**MUNICIPAL CORPORATION
KARACHI.**

Re: Plot No. 103. M.M.6.

AMENDED
PLAN SHOWING PROPOSED ADDITIONS & ALTERATIONS ON PLOT N: 103. SHEET N: M.M.6.
MACHIT MIANEE QUARTER
Scale 8 1/2" = 1" = 10' INCH

With reference to your application dated 13th February 1939 with a plan for the proposed buildings/additions and alterations on plot No. 103 Survey Sheet No. M.M.6, Machi Meani Quarter, I have to request you to comply with the following requirements:—

APPROVED.

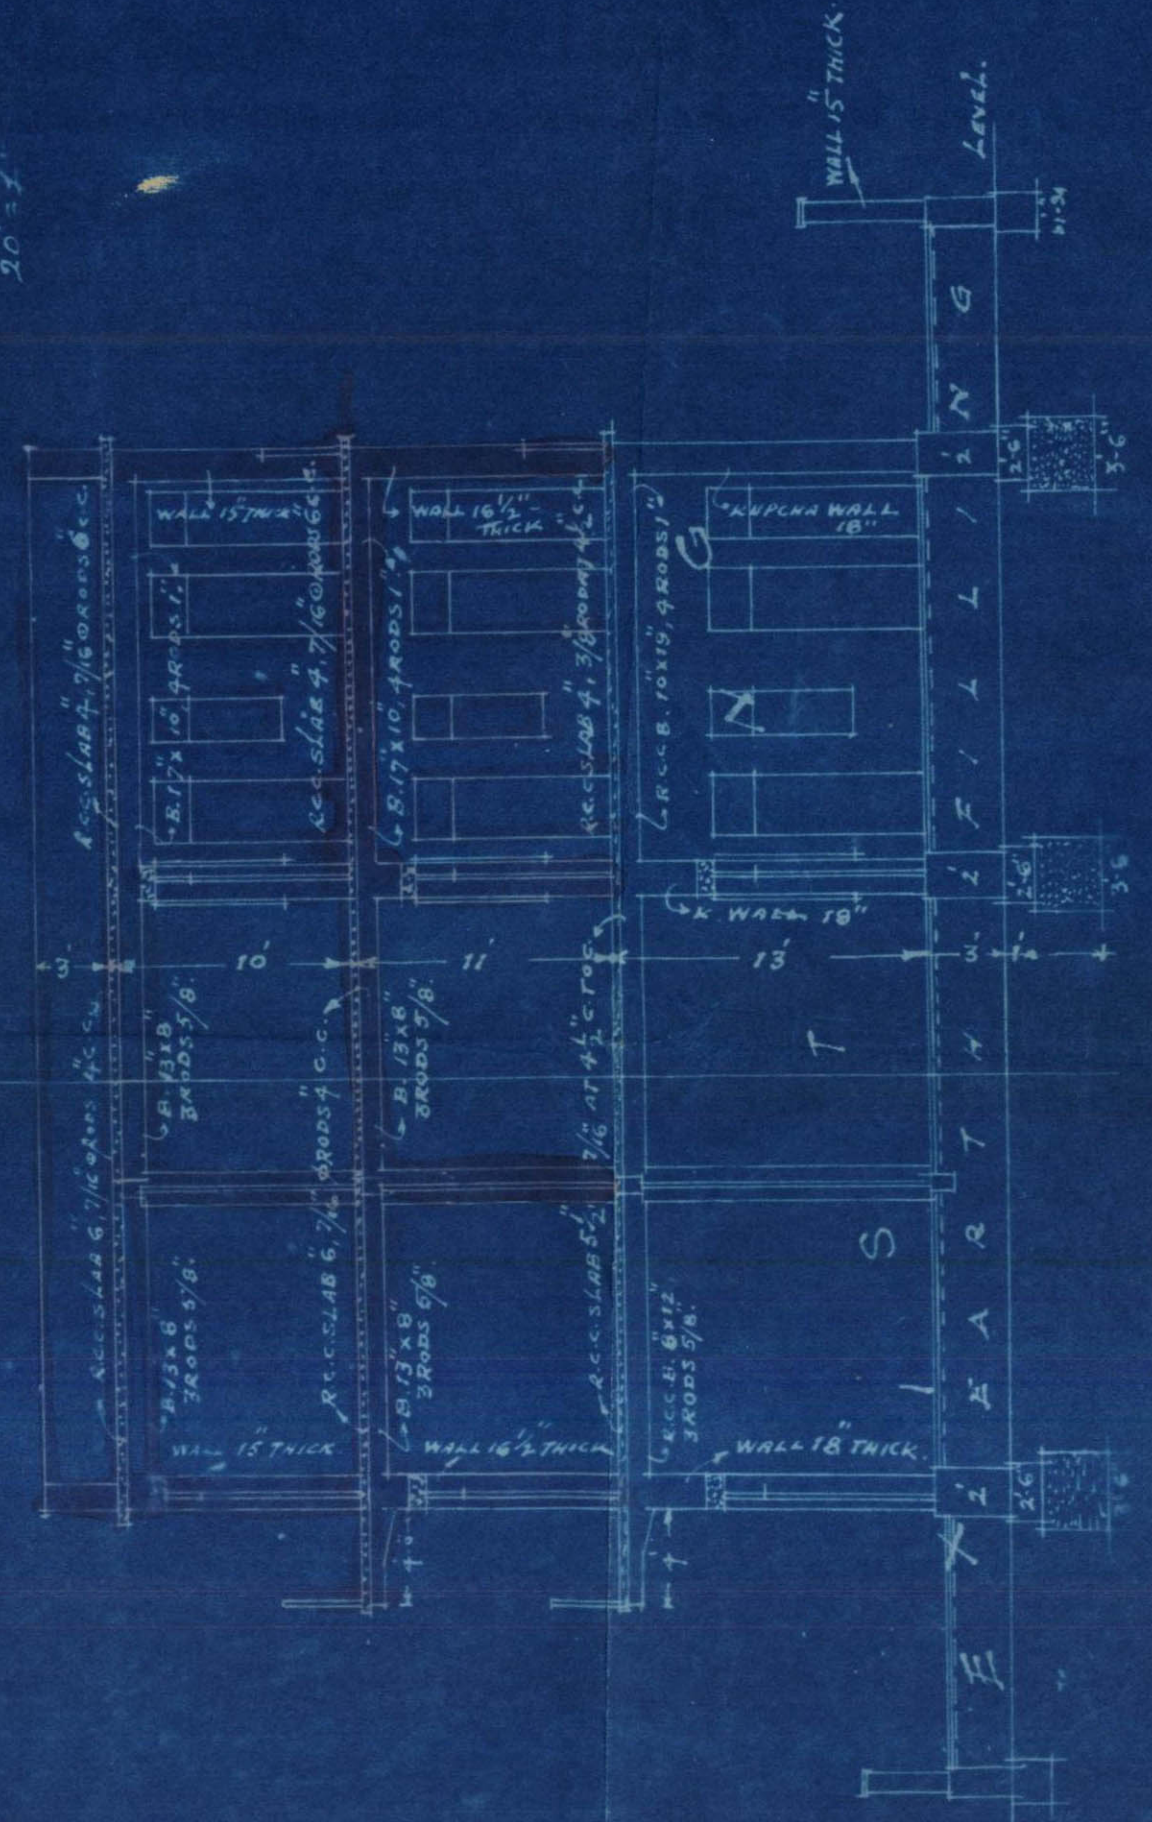
Note:-
Plan approved subject to
confining the built-up area
to 2/3 only of net area.

PLAN SHOWING PROPOSED ADDITIONS & ALTERATIONS ON PLOT No. 103. SHEET M.M.6 MACHI MIANEE QUARTER. - SCALE 8 FT. TO AN INCH.

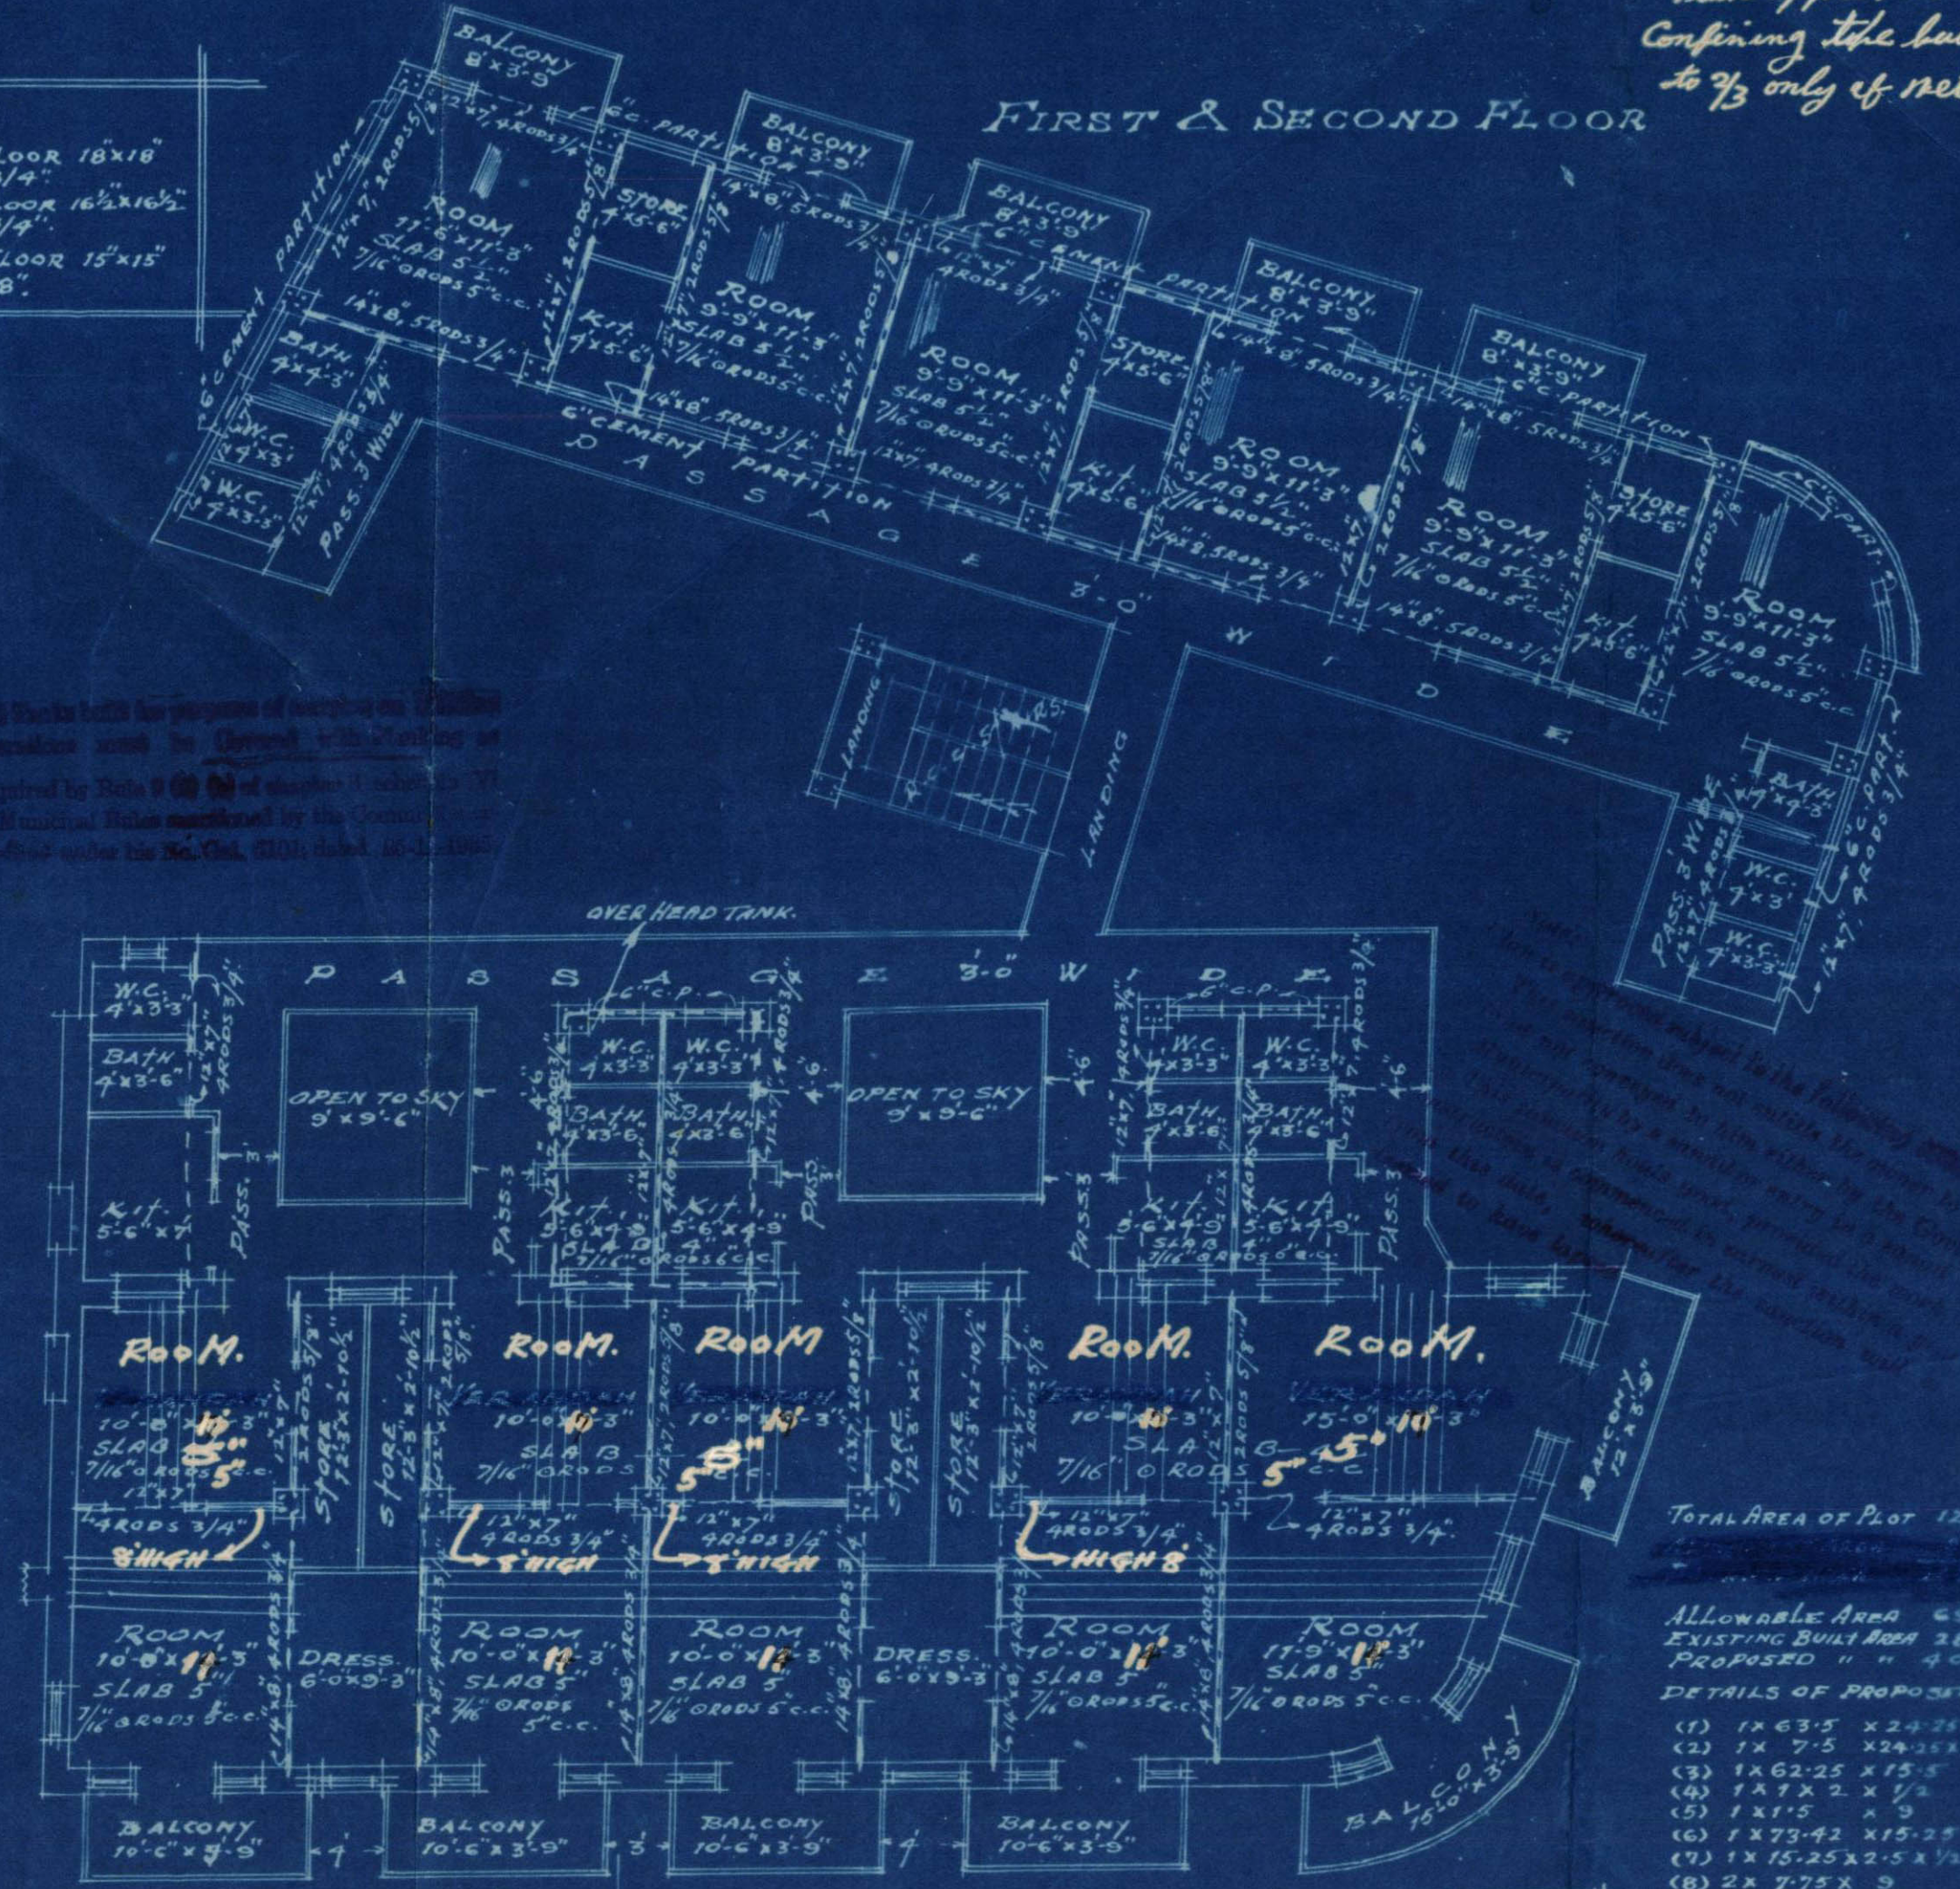
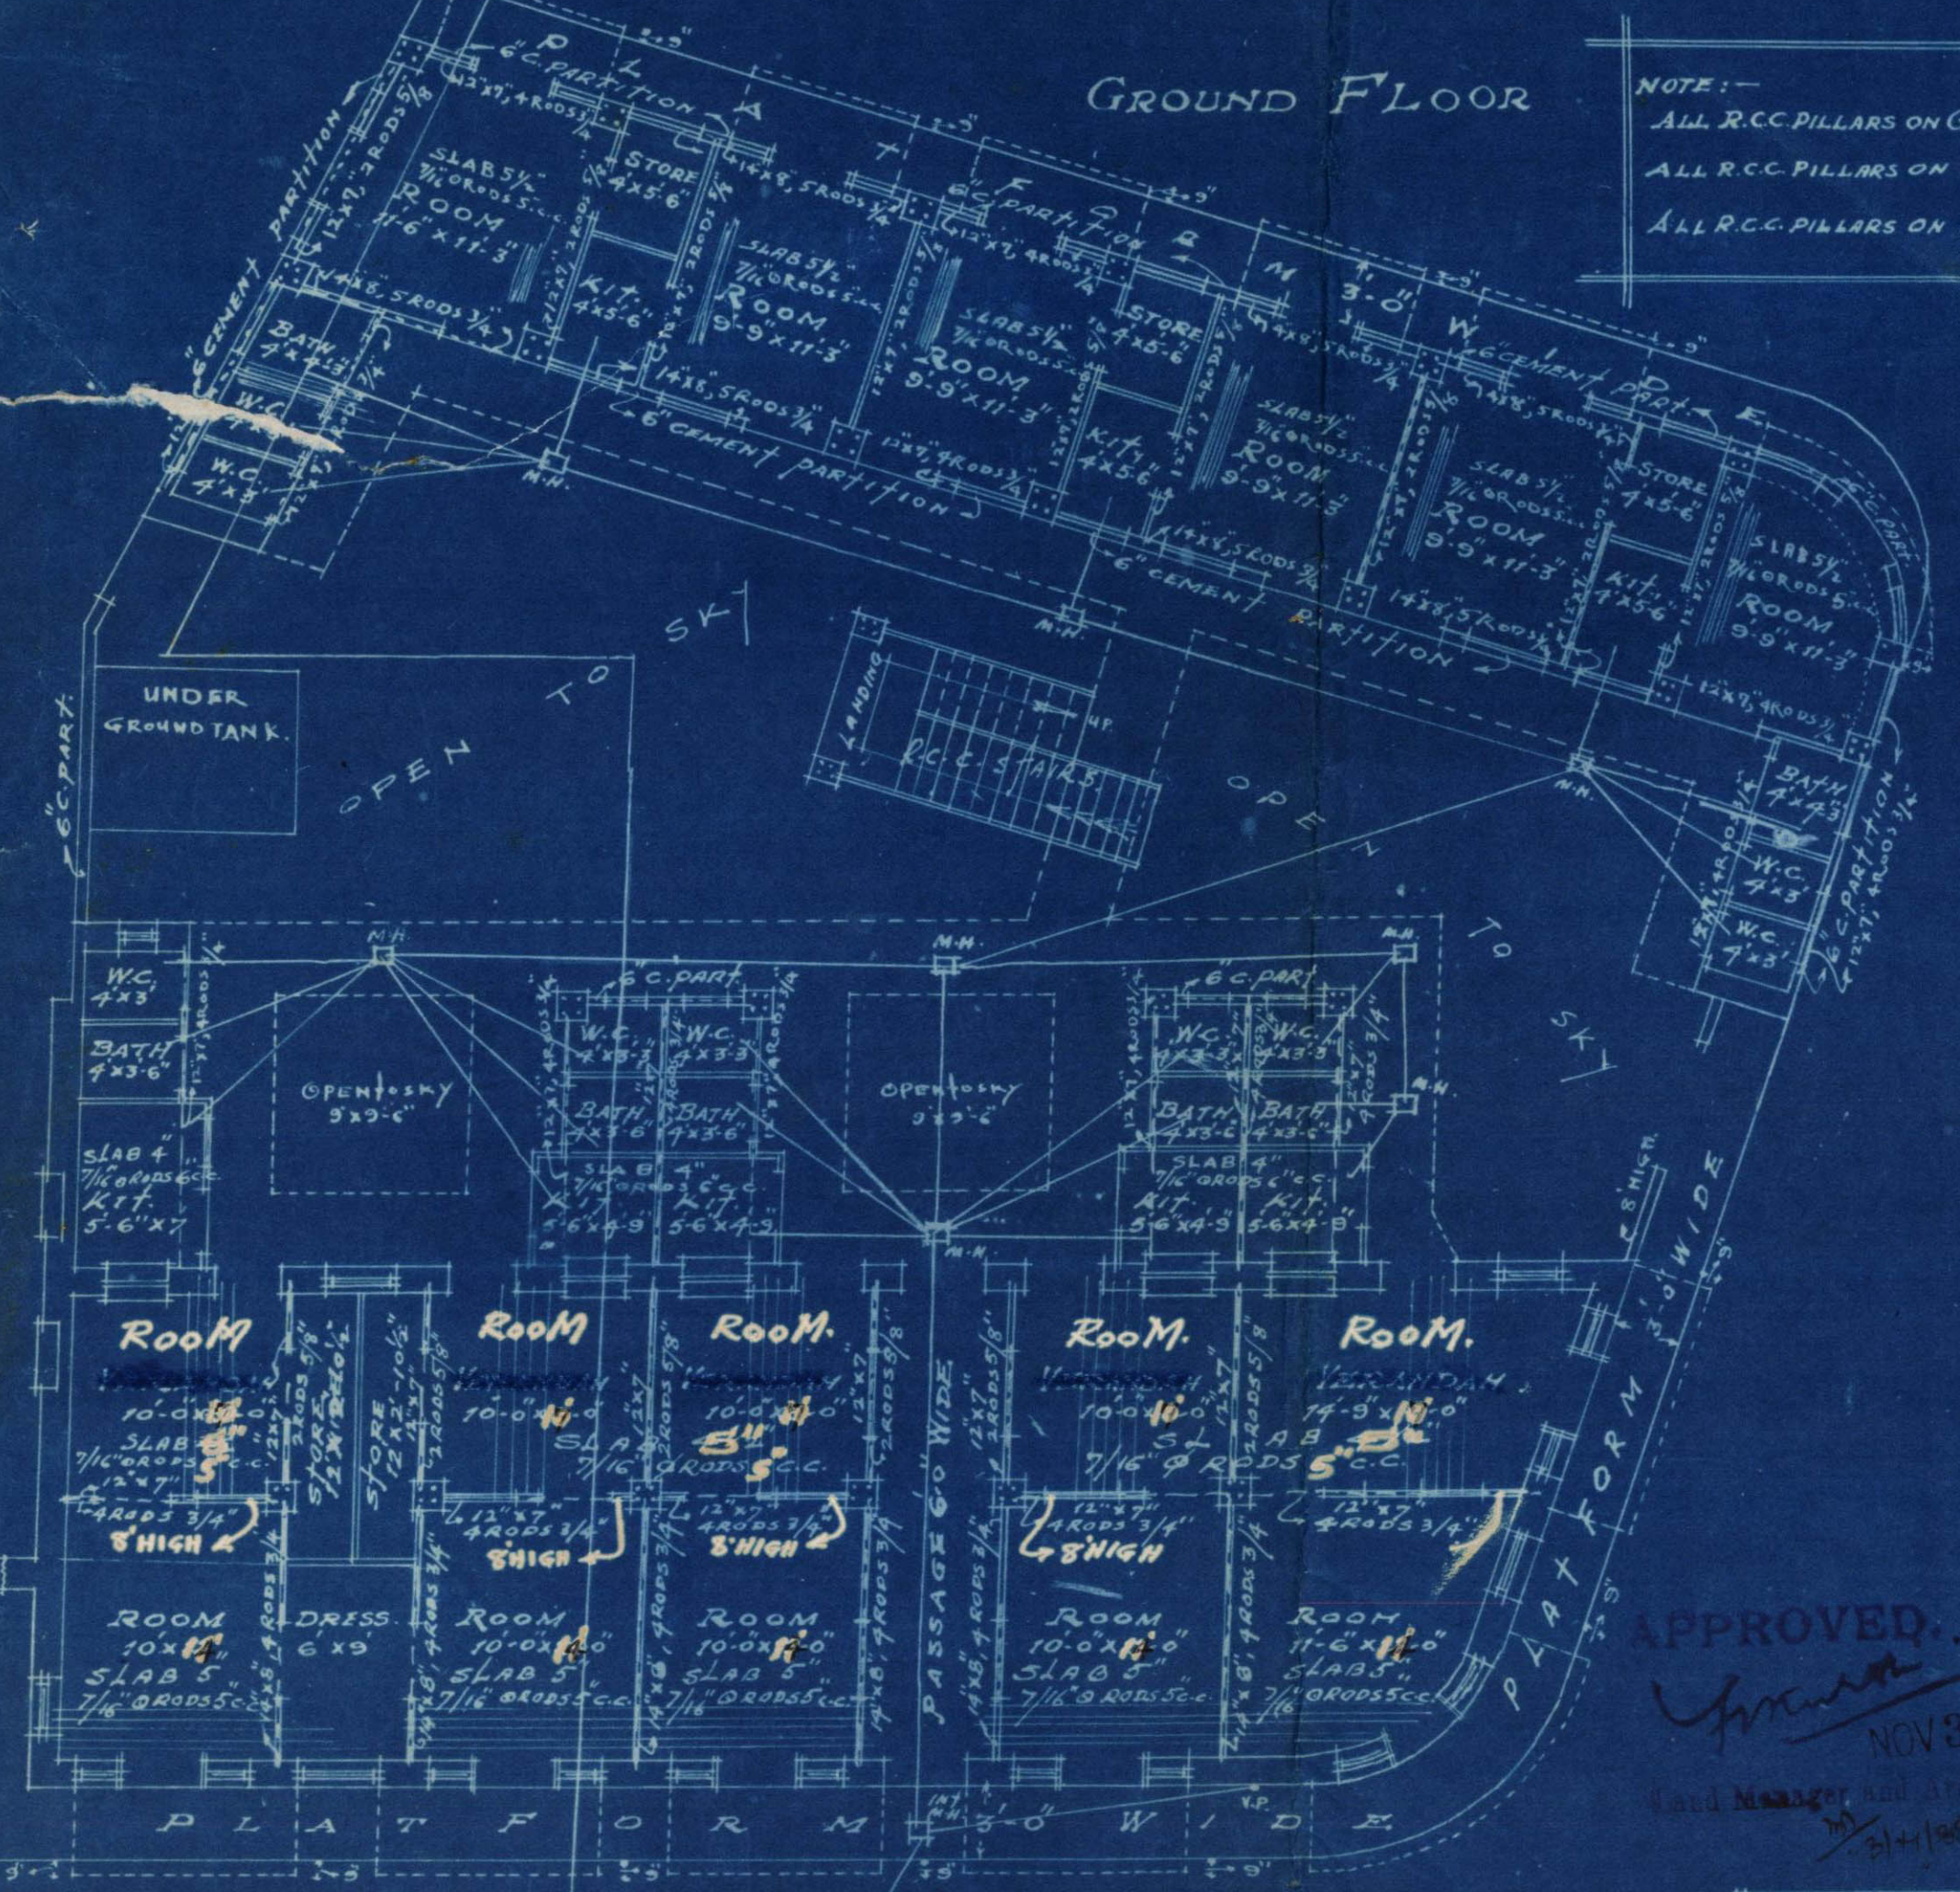
NOTE:-
 Plan approved subject to
 confining the built up area
 to 2/3 only of net area.
